Agility Textile (Pvt.) Ltd.

Latitude: [31.393564], longitude: [74.323596]
Date of inspection: 26-Feb-2026

Electrical Safety Inspection Report

Pakistan Accord Initial Safety Inspection Report

Figure 2.6 - Hot spot found on the circuit breaker cable connection in the stitching distribution board on the first floor

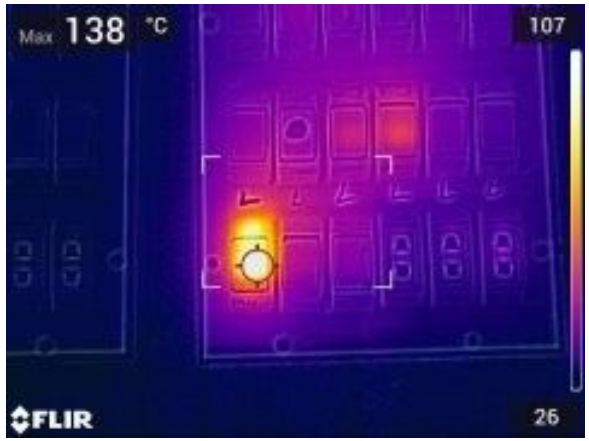
The categories of identified hot spots have been evaluated as per the ANSI NETA MTS 2019 standard, Table 100.18. Hot spots were observed, particularly at the following locations:
i. 164°C at the circuit breaker cable connection in the stitching distribution board on the first floor near the cargo lift.
ii. 138°C at the switchboard on the first floor of the main building.
iii. 58°C at the power socket in the basement hall of the main building.

Hot spots in electrical systems pose significant life safety risks due to several factors. Overheated components can ignite surrounding materials, leading to electrical fires. This is particularly dangerous in densely packed panels and distribution boards where flammable materials may be present. Hot spots can degrade insulation on wires and components, increasing the risk of electrical shock to personnel who might come into contact with exposed conductive parts. Overheating can contribute to conditions that might trigger an arc flash, a dangerous high-temperature event that can cause severe injuries or fatalities to personnel working near the affected equipment.F-202603-063643

Timeline	Remediation Plan
Immediate CAP-0074739	Any circuits identified on site with temperatures exceeding 40°C above the ambient temperature, operating above 90°C or exhibiting visual signs of burning must be immediately isolated and taken out of service. These circuits should remain de-energized until a thorough review has been conducted and appropriate remedial actions have been implemented to resolve the underlying issues.
Medium Term CAP-0074740	During the inspection, several circuits were identified where the temperature was exceeding 20°C above ambient temperature. It is recommended that the factory conducts comprehensive thermographic surveys of all electrical panels to detect similar issues. Identified hot spots should be thoroughly reviewed to determine their underlying causes. Corrective actions must be taken to address and resolve these issues, ensuring safe and reliable operation of the electrical systems.
